DATE: October 4, 2024

SUBJECT: Design Alternatives for Low Volume Driveway Highway Occupancy Permits

FROM: Daniel Farley, P.E., Director *Daniel Farley*
Bureau of Operations

**Alternate Low Volume Driveway with Consideration for
Combination Trucks, Buses, and Single-Unit Trucks**

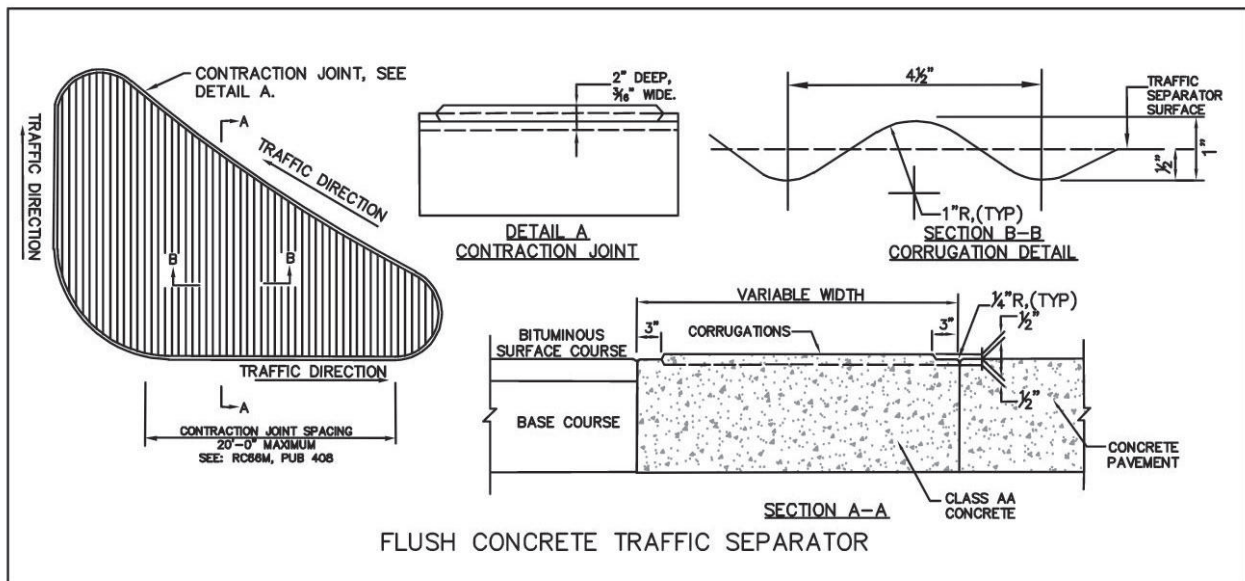
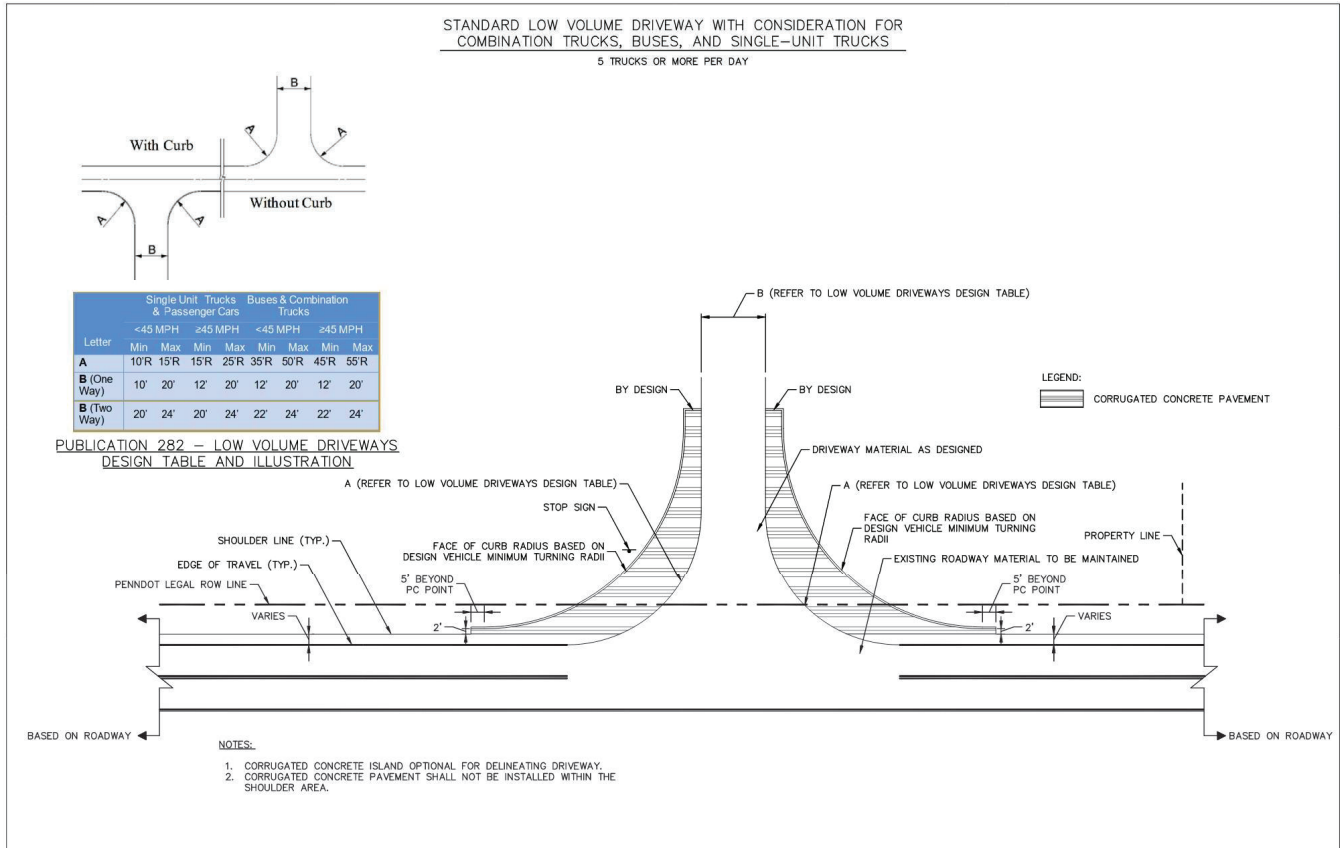
Refer to the alternate low volume driveway designs below when larger occasional vehicles do not meet the standard low volume driveway design parameters. An example of this would be a land use that traditionally services passenger vehicle traffic but also receives daily deliveries from combination vehicle(s). It is the responsibility of the applicant to understand the land use's day-to-day impacts.

Flush corrugated concrete pavement can be used for delineating driveways used by both passenger cars and heavy vehicles, to help prevent encroachment onto opposing lanes. The flush corrugated concrete pavement design is shown on page 48B. If the flush corrugated concrete pavement overlaps a pedestrian crossing an appropriate cut-through must be provided for ADA compliance. Flush corrugated concrete pavement shall not be installed within the shoulder area.

The design preference is flush corrugated concrete pavement; however, roundabout truck apron curb may be considered in certain situations, per Publication 72M, RC-65M. When roundabout truck apron curb is used, it should be dyed, stained, or painted to avoid being mistaken for sidewalk. If a pedestrian crossing is required, flush corrugated concrete pavement shall be used in place of roundabout truck apron curb.
